SUBJECT: JUNE 2-4, 2003, MEETING SUMMARY: MEETING WITH DUKE  
COGEMA STONE & WEBSTER TO DISCUSS CHEMICAL SAFETY  
RELATED TO MIXED OXIDE FUEL FABRICATION FACILITY

**MEETING SUMMARY  
MOX FUEL FABRICATION FACILITY  
June 2-4, 2003**

The purpose of the meeting was to discuss the draft Safety Evaluation Report (SER) chemical safety open items related to the construction authorization request (CAR) for the MOX Fuel Fabrication Facility (MFFF).

**Resulting Airborne Concentration as a Function of Wind Speed Over the Spill  
(500 liters of 13.6 N Nitric Acid Spilled over 50 sq. m)**

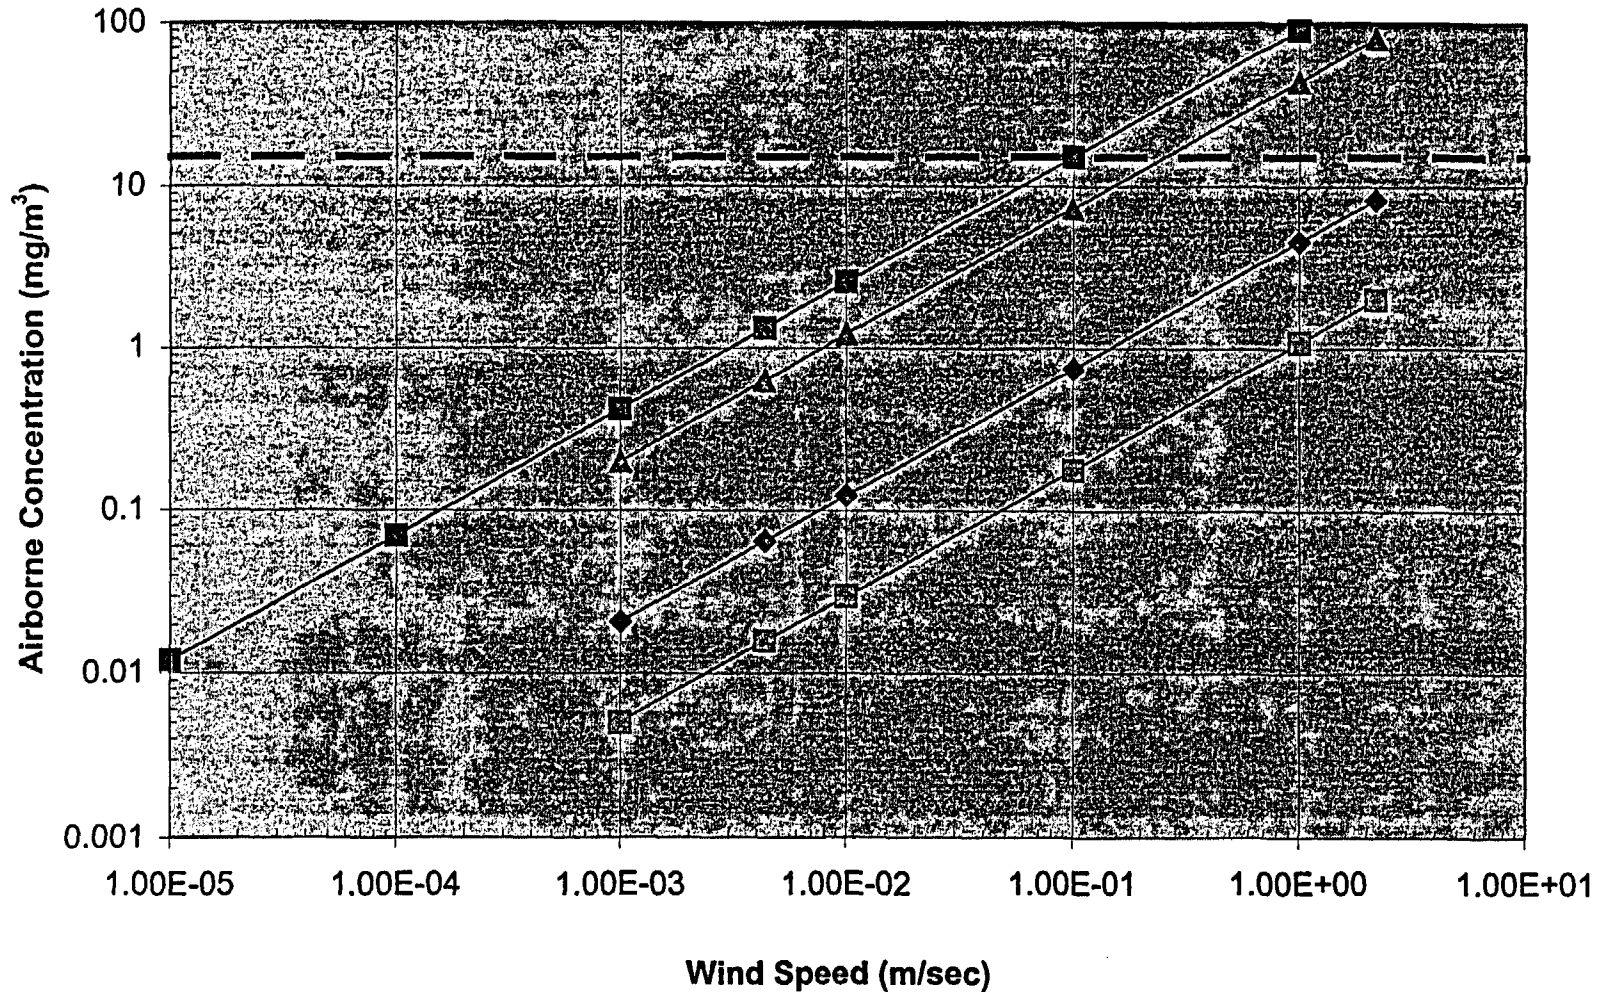
This item involved the effect of indoor airspeed on the calculational model used for determining whether a hot nitric acid spill in a cell could result in exceeding the performance criteria in 10 CFR Part 70. The applicant determined that for an uncontained spill and an average indoor airspeed of 0.01 m/sec, no consequence limits would be exceeded. The staff was concerned that the 0.01 m/sec airspeed was not realistic due to possible air duct locations near floor level that could significantly affect the evaporation rate of an uncontained spill. Specifically, the evaporation model is very sensitive to airspeed above the spill and an increase to 1 m/sec could exceed the low consequence limits. Additionally, the evaporation rates increase with temperature and could be substantial for temperatures above 110°C.

The staff conducted independent calculations using three different techniques (the guidance in NUREG/CR-6410, Nuclear Fuel Cycle Facility Accident Analysis Handbook, ALOHA and EPICode) and determined that the indoor air speed would conservatively have to be greater than a factor of five times the assumed average wind speed of 0.01 m/sec. to exceed the ERPG-2 value for a hot nitric acid spill (119°C) in the C-105 cell floor to exceed the low consequence limits for the site worker. The calculations assumed that the spill covered the entire 60m<sup>2</sup> floor area and did not take into account the conservative effects of the spill catch pan under the tank that is designed to contain the entire tank volume, or cooling from contact with the floor surface.

In addition to the above, DCS will do a cell by cell review during the ISA to confirm that low consequence limits will not be exceeded for any uncontained spill. Should the limit be exceeded, DCS indicated that the existing spill catch pan, already a principal structure systems and component (PSSC) for other scenarios, would be upgraded to a PSSC for this scenario. Since (1) there is a substantial indoor airspeed margin, (2) a cell by cell review will be conducted during the ISA, and (3) should the low consequence limits be exceeded for any cell assuming an uncontained spill (i.e., no catch pan), the applicant will upgrade the existing devices to PSSCs without impact on any construction activities, the staff considers this item closed.
